Havant Thicket Reservoir - Phase 9 Planning Application - APP/26/00574

Reserved Matters - NW layout, Visitor Centre, Bird Hide, Hub Building

I **object** to application APP/26/00574 for the following reasons;

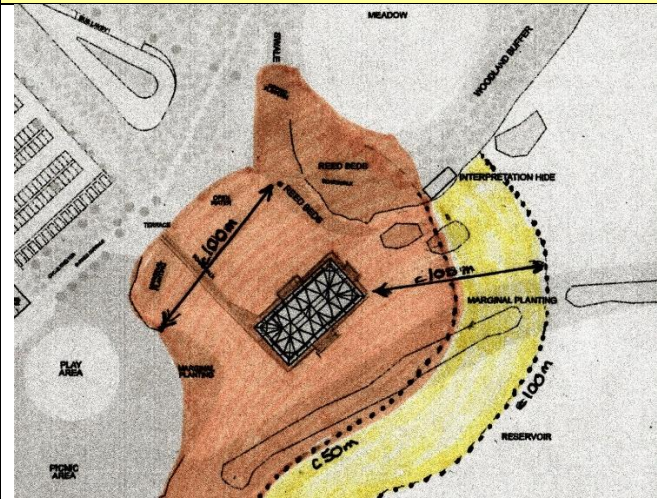
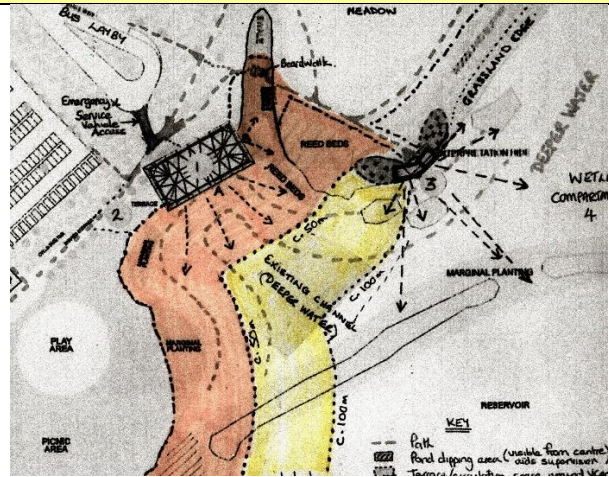
The education bird hide should incorporate a combination of fixed, near full-length windows glazed with one-way glass and smaller slotted, opening windows. This provides the best combination for educational / family use, and use by birdwatchers / photographers, who prefer not to look through glass.

Map 1 - Island Location - Visitor Centre as an island

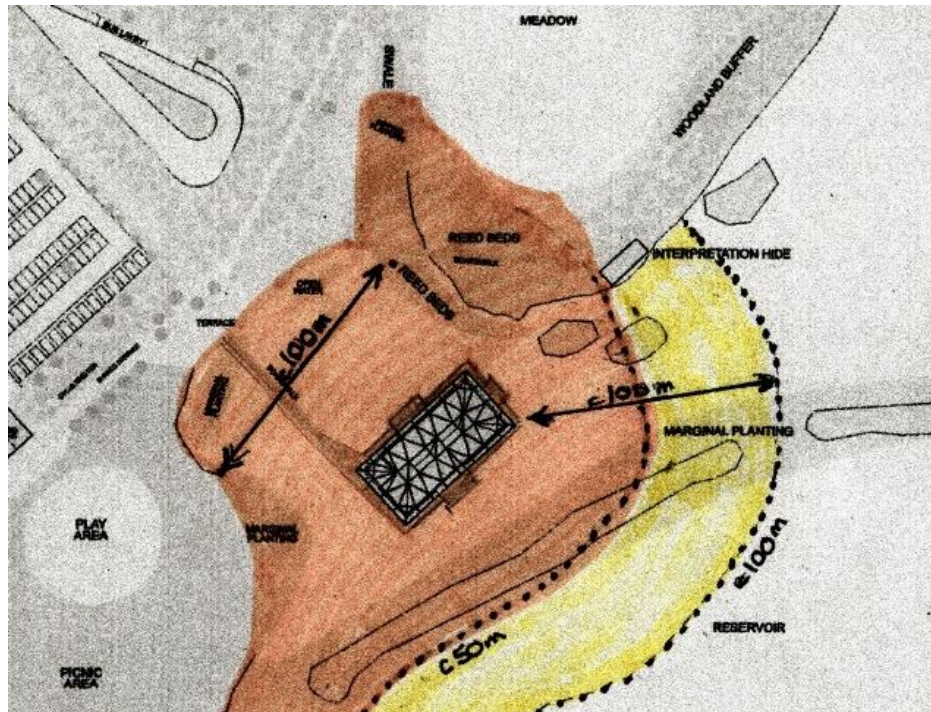
Unfortunately, the Phase 9 planning application, maps and illustrations for the NW corner of the reservoir site show the visitor centre (VC) as a floating pontoon island within the retained wetland, the primary conservation area of the site. Access is via a boardwalk over the water with a drawbridge, which will only add to the area of the wetland that is disturbed. [Redacted text] have repeatedly commented on the **inappropriateness of the island location within the wetland, because it extends the zone of disturbance for wildlife out into the wetland.**

For ease of reference, I have attached as Appendix A what I would anticipate would be the likely zones of disturbance for a VC located on the shore compared to that of the proposed island location [redacted text]. You will see that if the VC is sited as an island within the wetland the zones of disturbance extend much further out into the wetland and across the island of the wetland retaining structure. This also has the potential to include disturbance to the area of water in front of the bird hide reducing the educational opportunities for those using the hide. The zones are based on a lifetime's experience of watching and monitoring birds at wetlands. Where birds have access to open water and islands, as they will at the reservoir wetland, they behave very differently to birds in an open mudflat environment such as the Severn Estuary, which I believe the consultants used when assessing disturbance. Guidance based on disturbance monitoring of tidal mudflats should not be used as the basis for the assessment of the likely disturbance at the reservoir site.

Island location means high disturbance zone (orange) extends much FURTHER OUT into the wetland & reservoir.	Zone of high disturbance (orange) does NOT extend out as far into the wetland/ reservoir.
Reduced species diversity close to shore and VC (see orange box above), giving less for visitors to see. They would need a telescope to view more interesting species.	Greater species diversity likely to be present closer to shore and VC, increasing viewing experience/ opportunities for visitor engagement and education.
VC takes up valuable wetland habitat space which is completely unnecessary.	VC does not take up valuable wetland habitat, optimising the area of wetland habitat available.
Zone of maximum disturbance extends up to the education hide. The yellow zone of moderate disturbance extends in front of and beyond the Education Hide which will impact what can be seen. This can be avoided with careful siting of the VC to optimise the viewing opportunities from the education Hide.	Zone of maximum disturbance does NOT reach the Education Hide. The yellow zone of moderate disturbance only marginally impacts a small part of the view looking west from the Education Hide, ensuring great viewing opportunities & a broader range of species are more likely to be seen.

VC has excellent views out over the wetland and reservoir giving the 'wow' factor, the long access boardwalk, terrace on each frontage ensures the wetland habitat is disturbed so species available to view would be extremely limited (wasted opportunity)	VC on shore has excellent views south across wetland/ reservoir and to the east over swale channel and reedbed, still giving a great 'wow' visitor experience. Space at rear taken up by toilet, kitchen & offices so does NOT need great views.
Long boardwalk (c.25m) over water for access to the visitor centre maximises disturbance to the wetland as noise of people & silhouettes breaking the skyline is guaranteed to scare off wildlife. Noise of trolley wheels carrying supplies & wheelchairs over boards (hit & miss noise) will add to the disturbance.	Excellent screened access from carpark minimises disturbance from visitors arriving, providing simple ALL ability short access to VC. Great connectivity between VC & terrace. Trolleys carrying supplies enter from rear causing no disturbance to wetland.

VC sits on top of existing valley which would have flooded to provide deeper water habitat.	Existing valley feature (see contours on map above) when flooded will provide a variety of submerged vegetation and deeper water which diving species such as tufted duck and great crested grebe could use & still be visible from the shore & VC.
The majority of the retaining structure island south of the visitor centre will be within the disturbance zones, with 80% expected to be within the high risk disturbance zone (orange), reducing the biodiversity value of the island habitat, especially for birds.	Less than 50% of the retaining structure island south of the visitor centre will be within the disturbance zones, with just 15% within the high risk disturbance zone, protecting the habitats on the island from significant and regular disturbance.
New reedbed enhancement north of VC shown on an area which was formerly dry neutral to acid grassland which is <u>not</u> likely to form a wet reedbed habitat and will <u>not</u> stop visitor/dog access to the shore. Limited wildlife value does not compensate for the loss of c.1269m ² (27m x 45m) of high quality wetland habitat taken up by the island location of the VC.	Swale and new reedbed enhancement will add interest to the view from the east end of VC, but access routes from VC to Interpretation Hide mean it will be within the high disturbance zone anyway, so any disturbance from the VC will make no difference.

Map 2 - Shoreline Location - alternative siting would reduce disturbance of wildlife and impact on the wetland (located within permitted VC area box in outline hybrid permission)

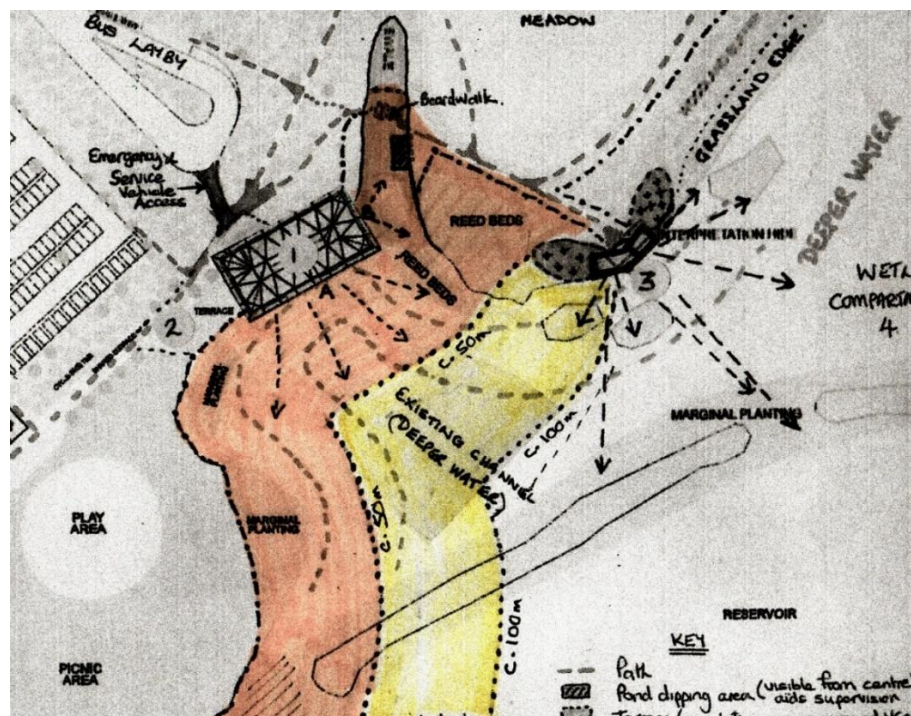
The undulating topography of the north-west wetland compartment means that it would have a good variety of water depths, including deeper water making it a highly valuable area for wildlife, especially a wide variety of waterbirds. It therefore seems particularly detrimental to physically locate the VC within this sector. **I do not support this at all. To provide a wetland habitat and then put the honey-pot location directly within it is bizarre!** The visitor centre is one of the areas where the greatest intensity of disturbance will occur, with large numbers of families with children and dogs. Why put that inside the conservation zone? Of course, I fully accept that the visitor centre needs to provide a view over the water, but this can be achieved by setting the centre back on the NW shore. The primary purpose of the retained wetland should always be conservation and the enhancement of biodiversity to help mitigate the loss of original habitats at the site. The box which set out the zone for location of the VC at the outline approval stage provided space for the building to be located on shore and I would recommend that is where it is located.
